Re: **RESUBMISSION** – 176 Virginia Road, North White Plains
(S/B/L: 122.16 – 1 – 3. Zone District: “IND-A “

**PRIOR BOARD APPROVAL – RESOLUTION DATED 4/25/22 (SIGNED 4/29/22)
(COPY ATTACHED)**

Action:	Site Plan, Steep Slope and Tree Removal Approvals
Application Name:	Mistis Properties 100 Inc. [2021-017]
Applicant/Owner:	Mistis Properties 100 Inc.
Designation:	122.16-1-3
Zone:	IND-A Zoning District
Acreage:	0.38 acres
Location:	176 Virginia Road
Date of Approval:	April 25, 2022
Expiration Date:	April 25, 2023 (1 Year)

SITE PLAN
1" = 20' - 0"

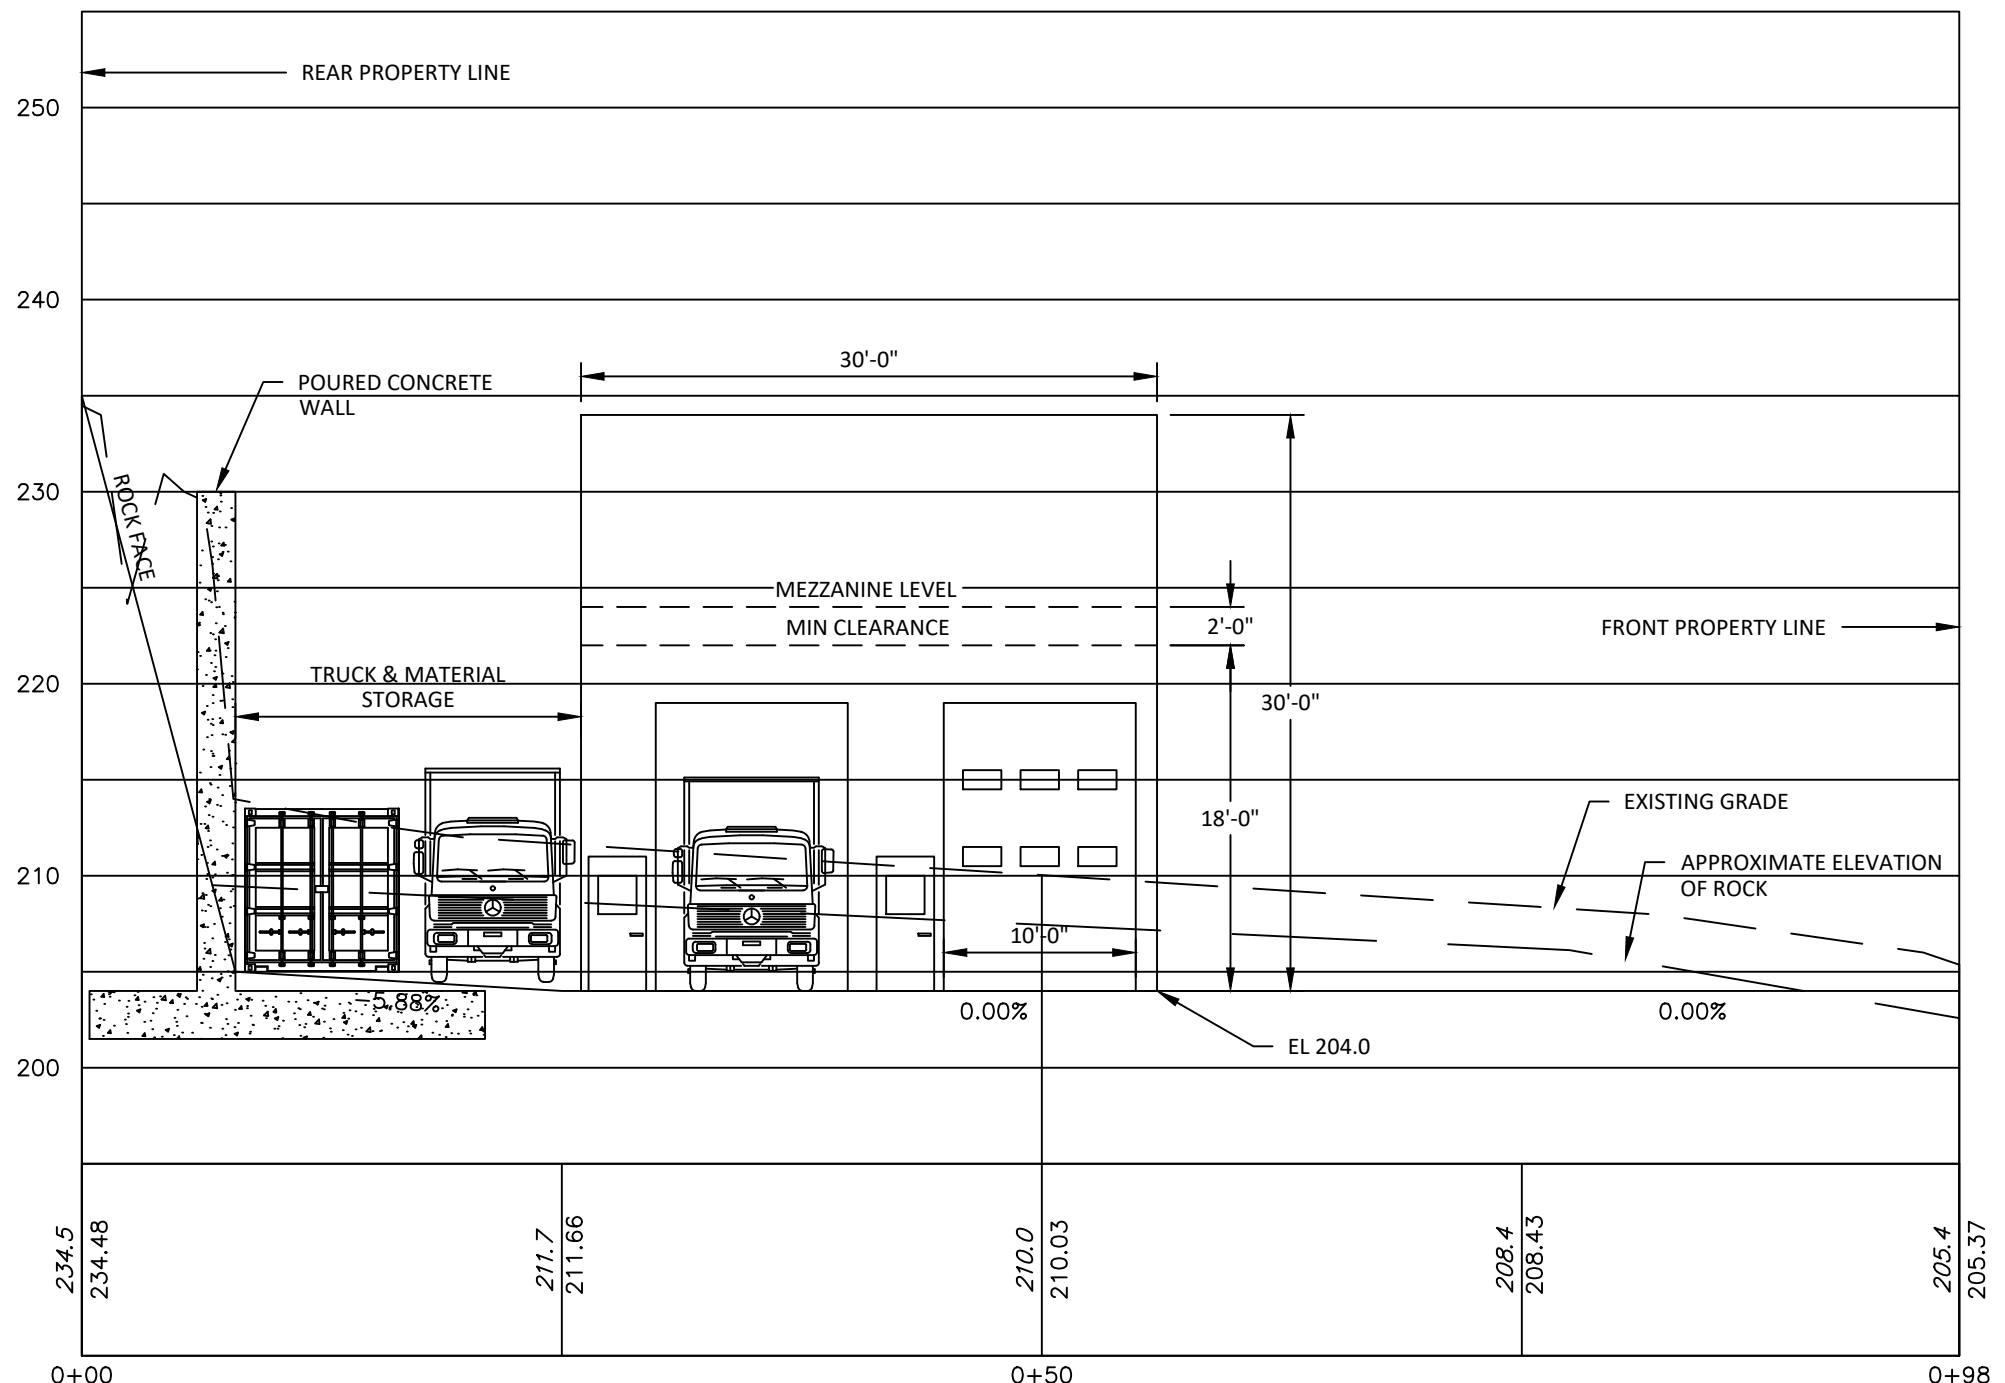
- _____ 1. The site plan shall be revised to contain a note stating that “Truck washing is limited to the trucks stored on the site and a maximum use of 200 gallons/day” to the satisfaction of the Planning Department. **NOTE ADDED ON SHEET 1 OF 7**

- _____ 2. The site plan shall be revised to contain a note stating that “Vehicle Repair shall be prohibited on site” to the satisfaction of the Planning Department. **NOTE ADDED ON SHEET 1 OF 7**

- _____ 3. The site plan shall be revised to contain a note stating that “Any outdoor storage of vehicles and material not depicted on the approved site plan shall be prohibited” to the satisfaction of the Planning Department. **NOTE ADDED ON SHEET 1 OF 7**

- SITE PLAN NOTES:**
- TRUCK WASHING IS LIMITED TO THE TRUCKS STORED ON THE SITE AND A MAXIMUM USE OF 200 GALLONS/DAY.
 - VEHICLE REPAIR SHALL BE PROHIBITED ON SITE.

- ANY OUTDOOR STORAGE OF VEHICLES AND MATERIAL NOT DEPICTED ON THE APPROVED SITE PLAN SHALL BE PROHIBITED.
 - Prior to the start of construction and throughout the construction period, area of disturbance lines shall be clearly delineated in the field with snow fence or another demarcation acceptable to the Building Department and Town Engineer, which shall be placed around the entire proposed construction area. Except as necessary to provide mitigation plantings, no encroachment beyond these limits by workers or machinery shall be permitted.

DRAINAGE & GRADING PLAN
1" = 20'-0"

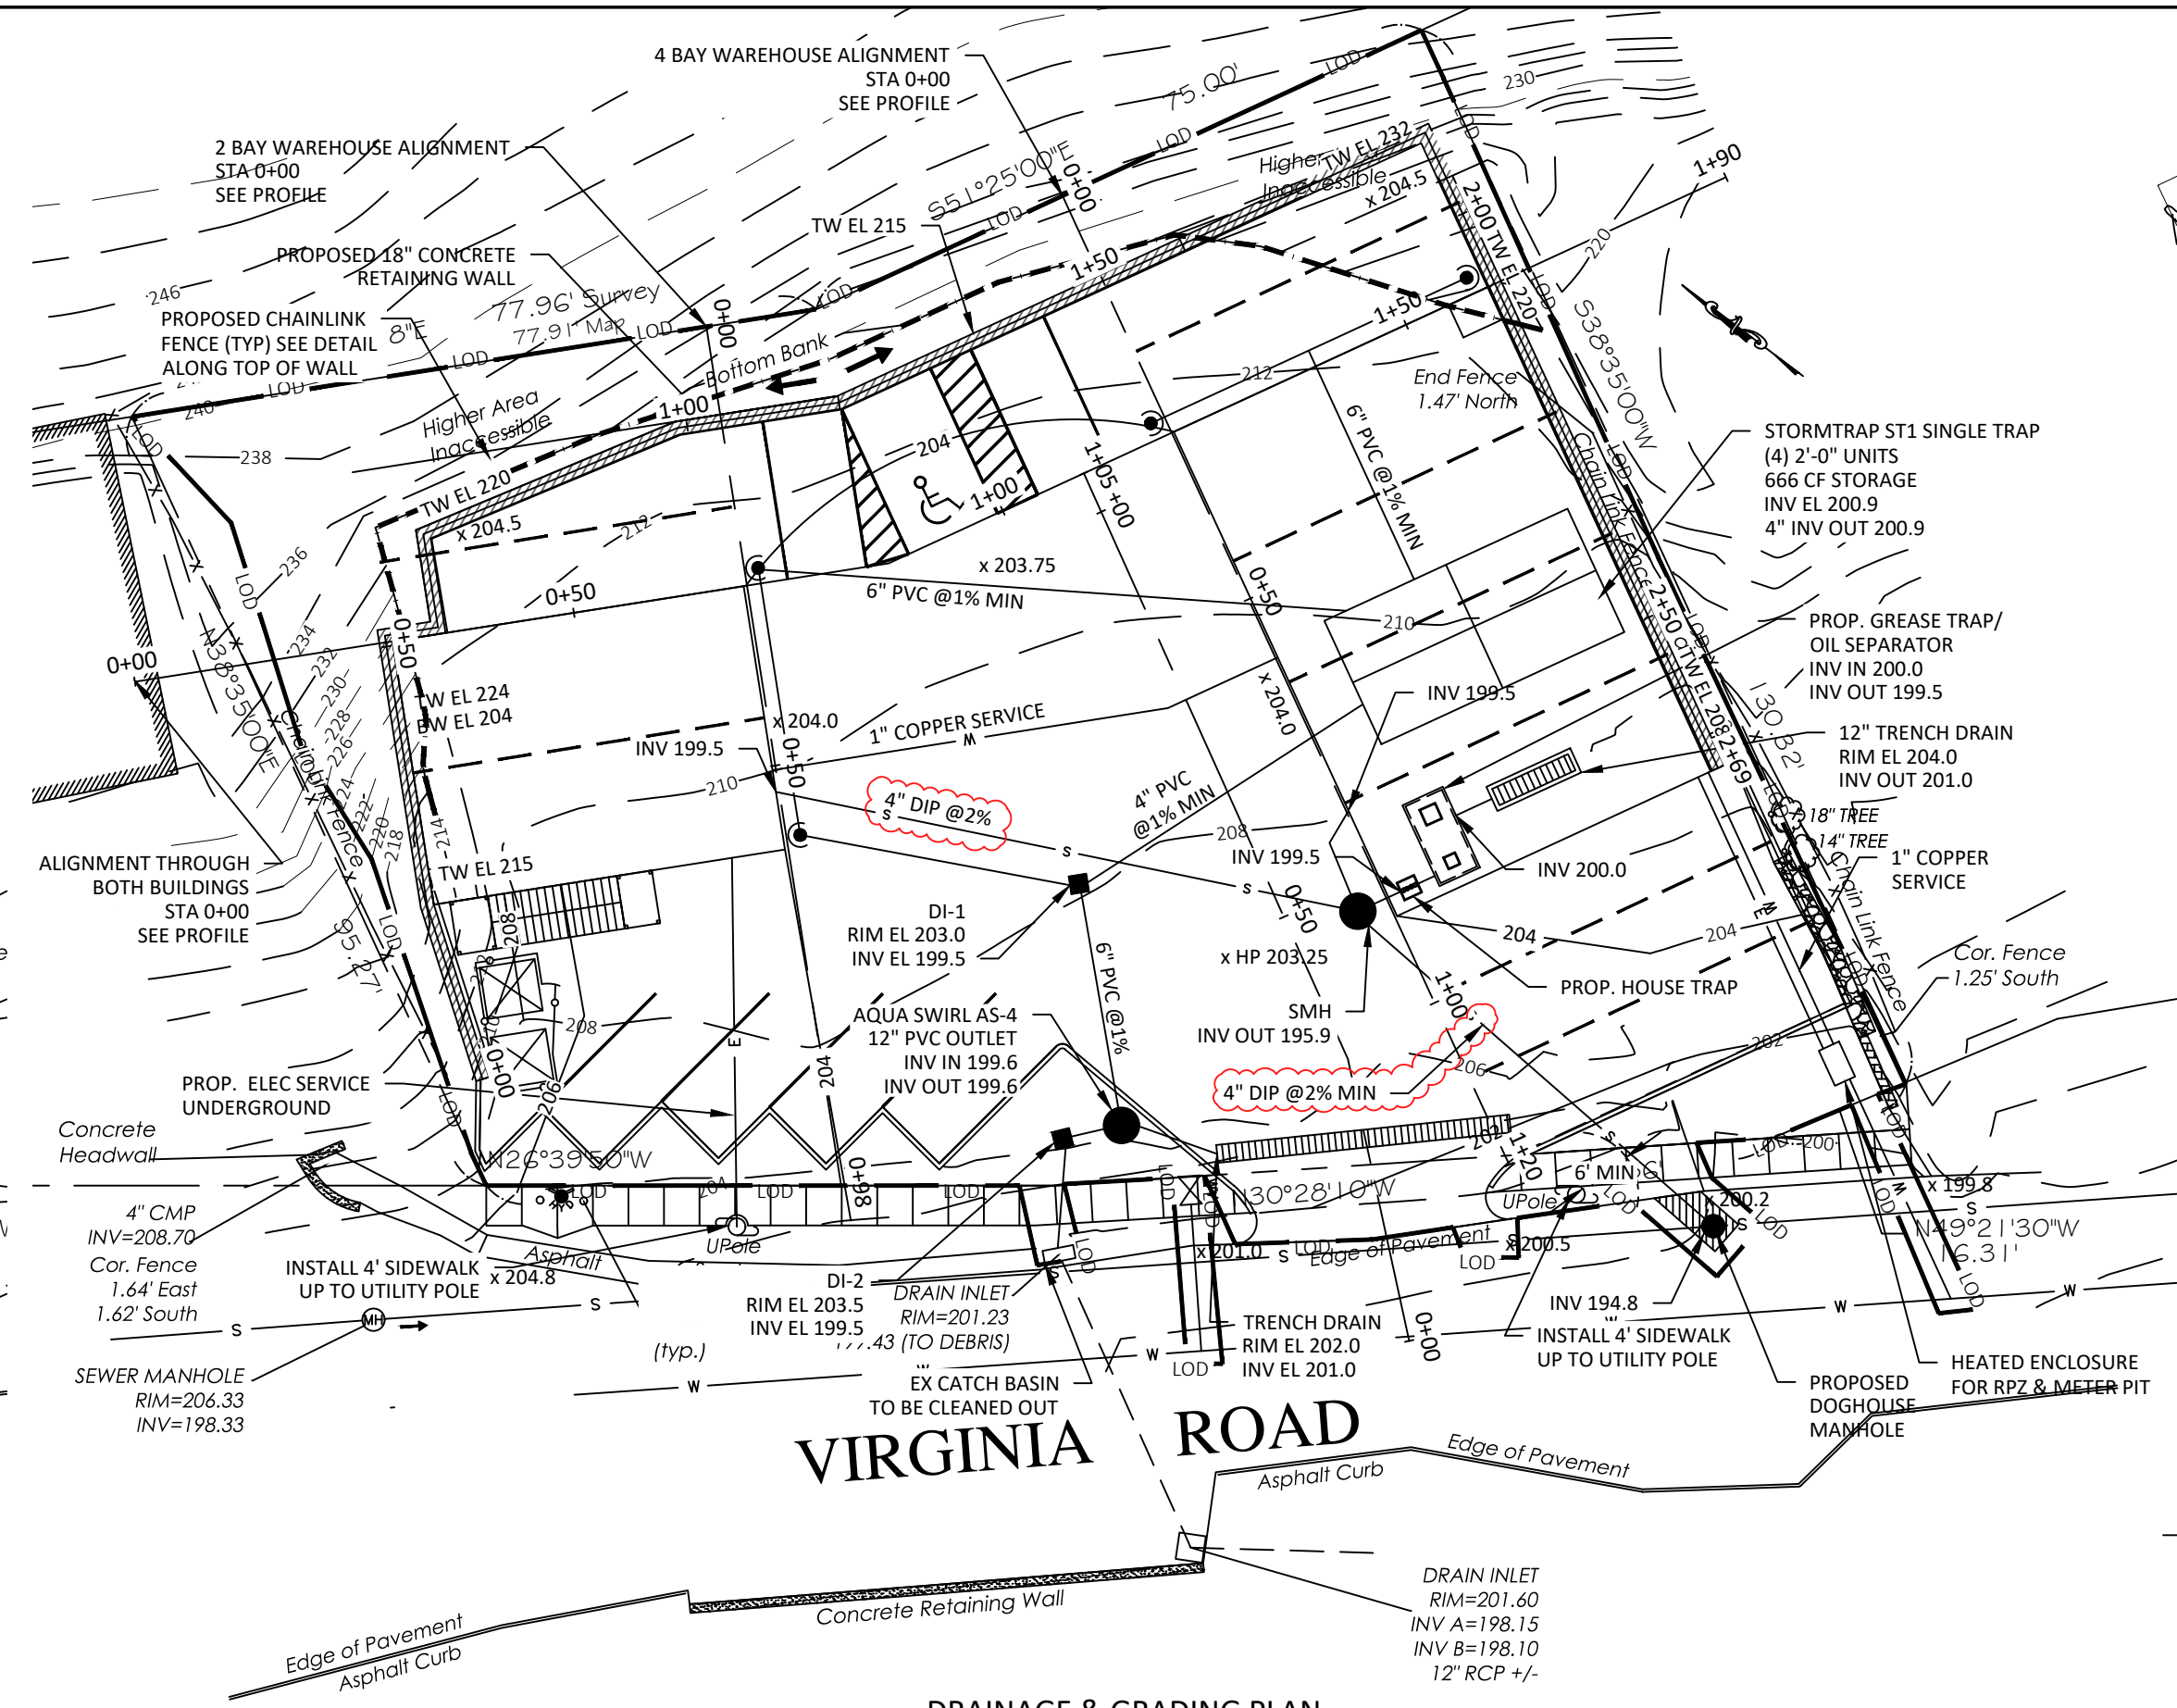
7. The proposed outlet structure needs clarification. The detail on Sheet S-5 indicates a connection to the hydrodynamic separator; however, there is no indication of this on plan Sheet S-2. The detail also indicates outlet pipes of twelve (12) inch and four (4) inch diameter, while the plan illustrates a six (6) inch outlet pipe to Drain Inlet, DI-2. Please clarify. It appears that an additional structure will be required for the pipe transition or an alternate outlet structure design. The six (6) inch pipe connection should also be included in the hydrologic model. It currently appears to be undersized. **Noted we need to redraw. will do after submit**

7. The proposed outlet structure need clarification. The Detail on Sheet S-5 indicates a connection to the hydrodynamic separator: however, there is no indication of this on plan Sheet S-2. The detail also indicates outlet pipes of twelve (12) inch and four (4) inch diameter, while the plan illustrates a six (6) inch outlet pipe to Drain Inlet, DI-2. Please clarify. It appears that an additional structure will be required for the pipe transition or an alternate outlet structure design. The six (6) inch pipe connection should also be included in the hydrologic model. It currently appears to be undersized.

- _____ 7. The location of the final connection of the sanitary sewer shall be adjusted to avoid conflict with the existing utility pole and maintain a minimum six (6) foot clear to the satisfaction of the Town Engineer. The sewer connection shall be made with a dog house sanitary manhole vs. the cut-in tee-wye as shown. **Sheet 2 of 7 DRAINAGE AND GRADING PLAN REVISED TO INCLUDE DOGHOUSE MANHOLE**

Plans were updated as per comment. (See plan on Sheet S-2 and Detail on Sheet S-5)

SEWER MANHOLE DETAIL
N.T.S.

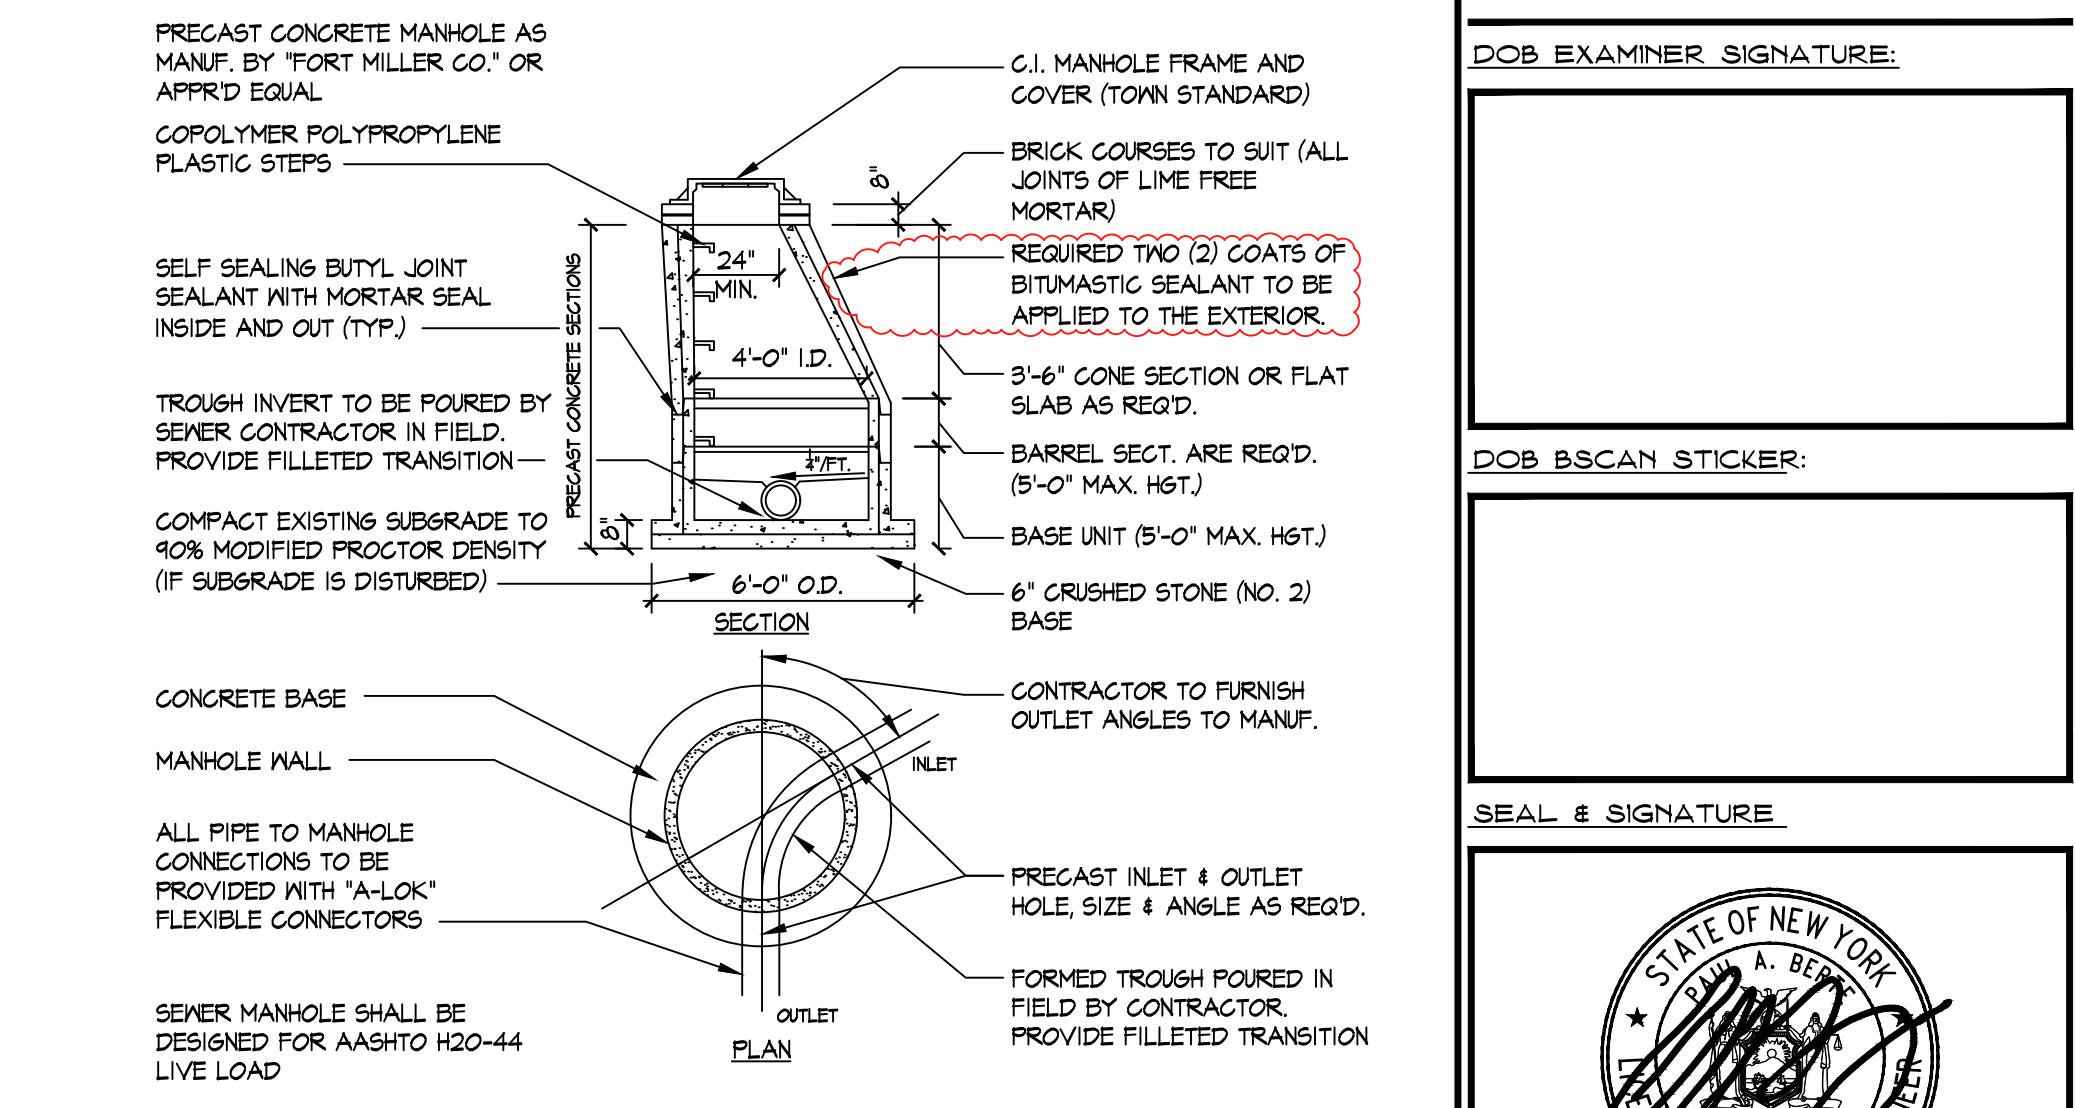
3. The proposed Frame and Cover Detail on Sheet S-5 shall require that manhole covers for sanitary sewers be stamped with "SEWER" on the casting.
4. The sanitary manhole detail included on Sheet S-2 shall be revised to require two (2) coats of bitumastic sealant to be applied to the exterior.

4. The sanitary manhole detail included on Sheet S-2 shall be revised to required two (2) coats of bitumastic sealant to be applied to the exterior.
Plans were updated as per comment. (See note in Sewer Manhole Detail on Sheet S-2.)

WATER SERVICE CONNECTION
NTS

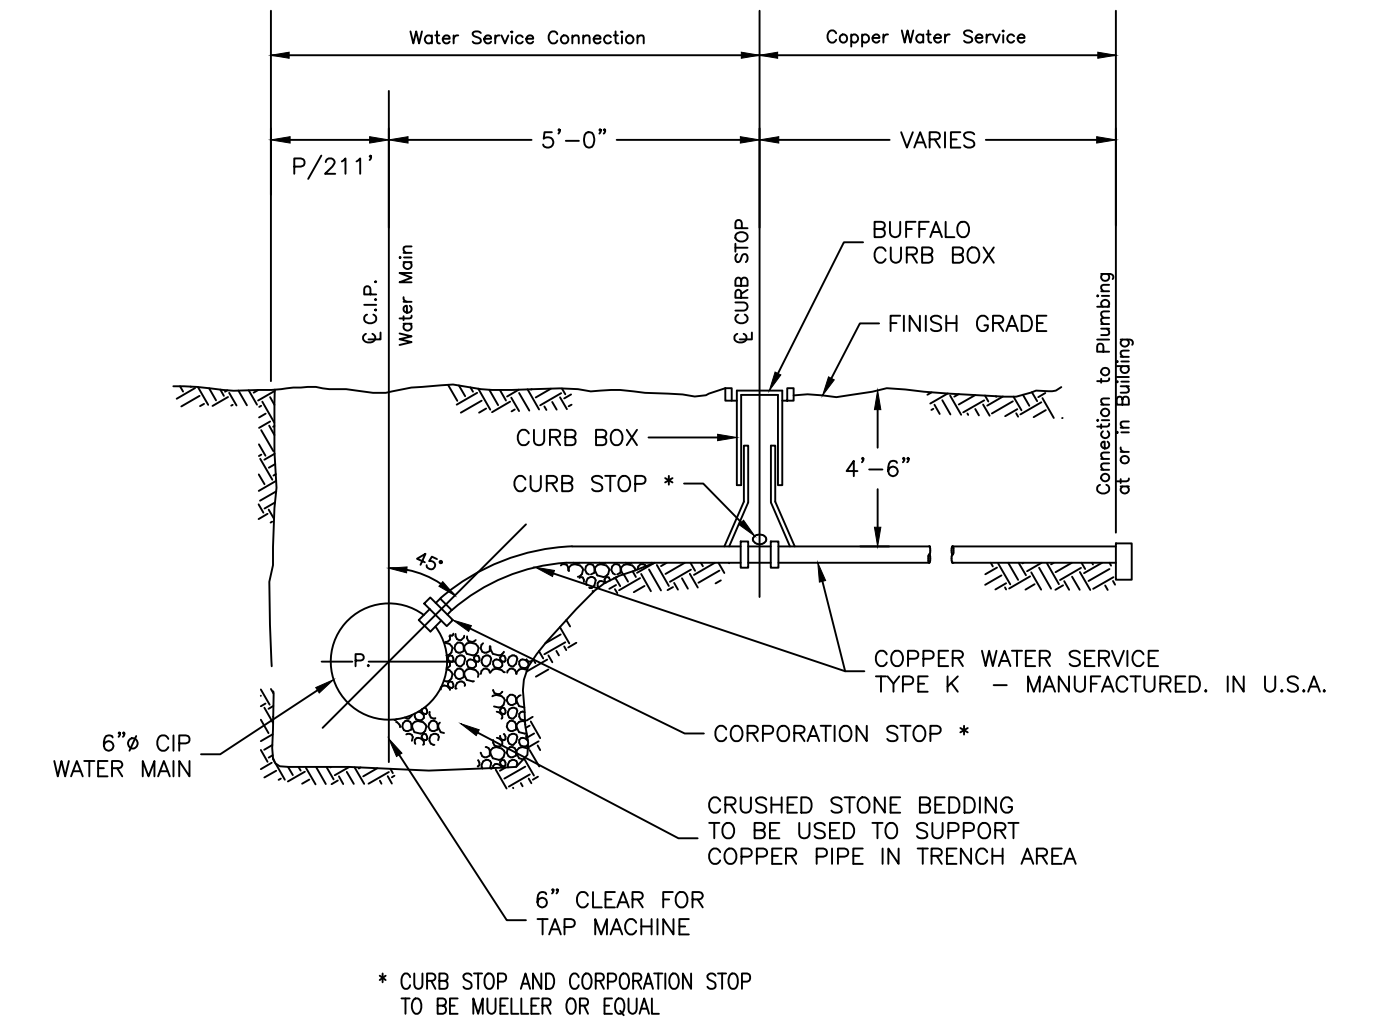
- I did not see a fire service in the design, although not a requirement of this department, just wanted to make sure it was not an oversight.
- The water service connection detail shows the curb stop within 5' of the water main. That is unlikely as the water main is closer to the middle of Virginia Road. When the water tap is installed the curb box is set at the property line.
